Subject: Jordan Ranch – Parcel H (Case # R00002918)  
Dublin, California

### **STOCKPILE REUSE PLAN AND REPORTING**

Reference: Alameda County Environmental Health Services, Case File Review for SCP Case No. RO0002918 and GeoTracker Global ID T06019797353, Jordan Ranch, 4233 Fallon Road, Dublin, CA 94568, November 26, 2014

FIGURE NO.  
**2**

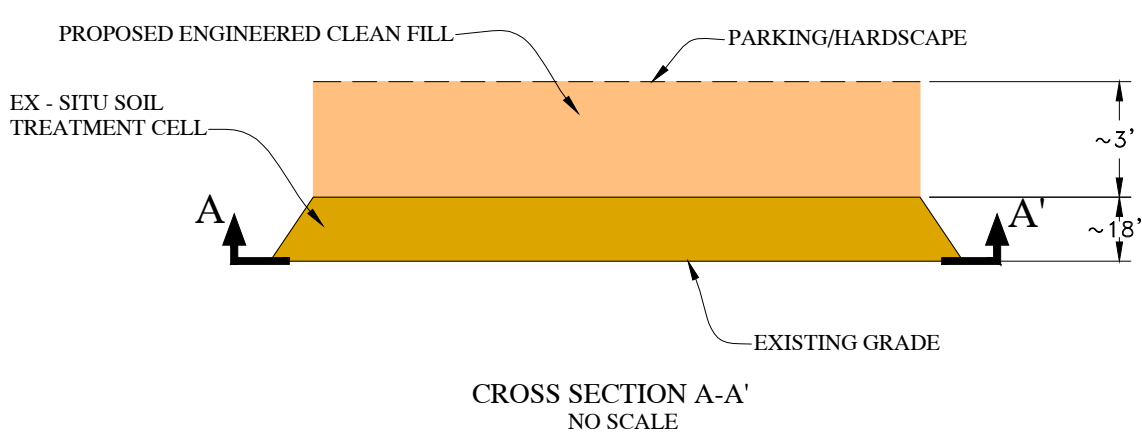
Comment 2: The attached Figure 2 – Proposed Soil Reuse Plan Profile depicts the current development plan and final location of the treated stockpile in plan view and cross section view. As shown on Figure 2, the stockpile is located greater than 100 west of the pond. The proposed final grade elevations shown on the development plan confirm approximately 3-5 feet of clean fill capped with parking space/hardscape is to be placed above the existing stockpile elevation. The proposed residential development will not have pools or substantial side yards. The shallowest groundwater encountered during drilling at the site was at 10 feet below existing grade, therefore the stockpile location meets the 5 foot separation from groundwater criteria. The stockpile is currently protected by stormwater BMPs as part of the active SWPPP program at Jordan Ranch.
